Work Order ID 114826

Item Name: Aft Crosstube - High

| DRAWING NO. D412-664-243 | TITLE CROSSTUBE ASS'Y (412 HI AFT) | REV. E | DART AEROSPACE LTD ENGINEERING ORDER | | D.E.O. NO. D412-664-243-E-2 | SHEET NO. SHEET 1 OF 1 | SCALE NTS |

**D412-664-243
ASSEMBLY DETAIL**

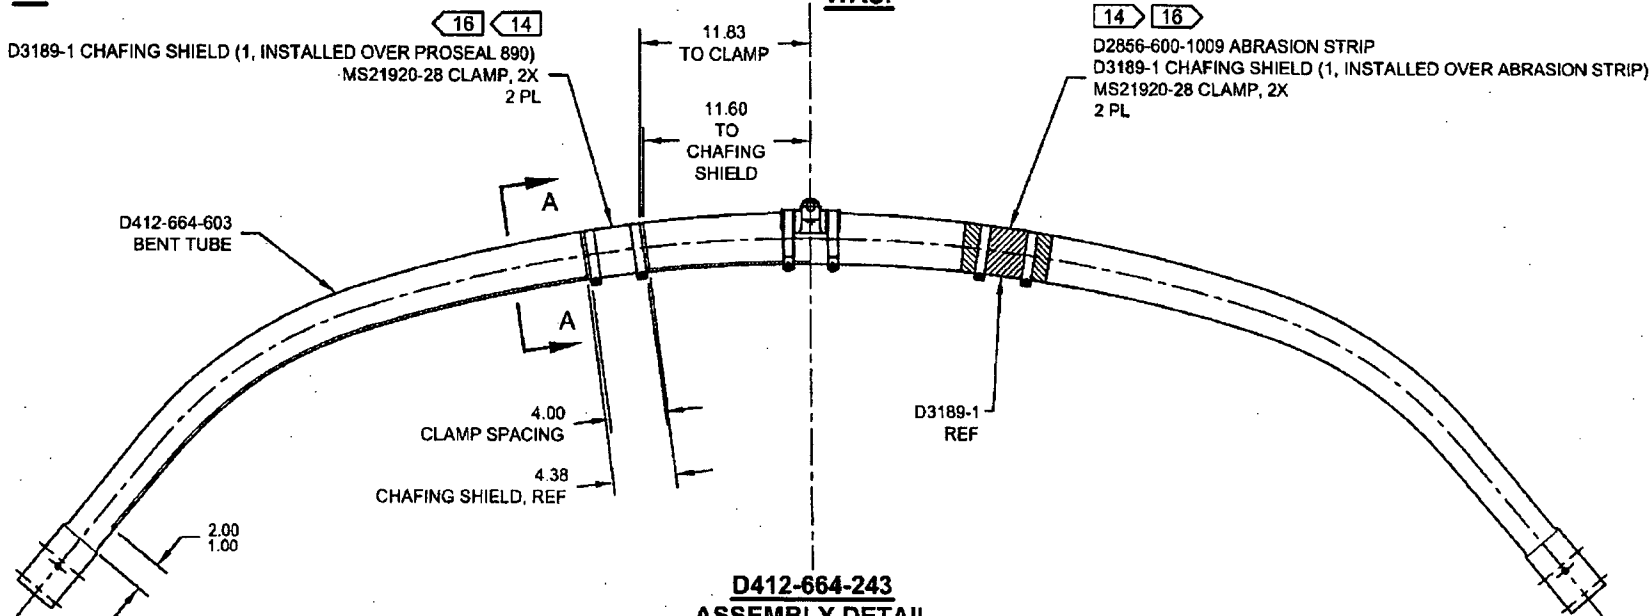
IS:

D3189-1 CHAFING SHIELD (1, INSTALLED OVER PROSEAL 890)
MS21920-28 CLAMP, 2X
2 PL

D2856-600-1009 ABRASION STRIP
D3189-1 CHAFING SHIELD (1, INSTALLED OVER ABRASION STRIP)
MS21920-28 CLAMP, 2X
2 PL

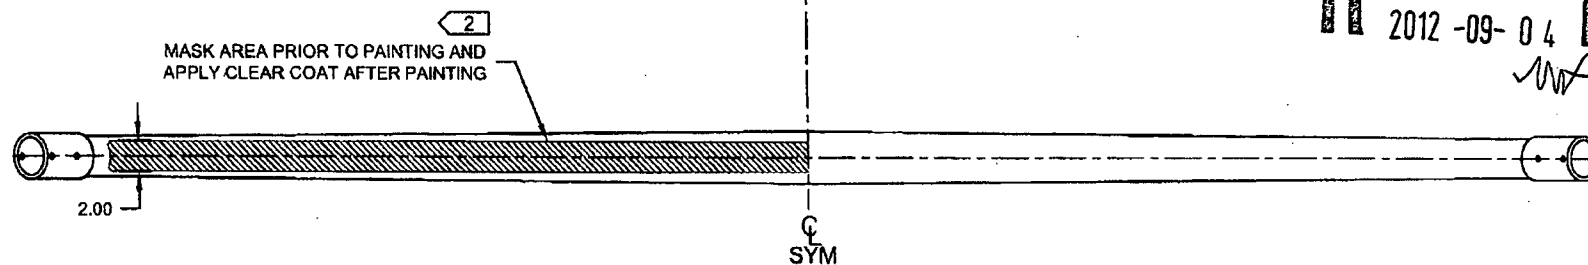
MASK AREA PRIOR TO PAINTING AND
APPLY CLEAR COAT AFTER PAINTING
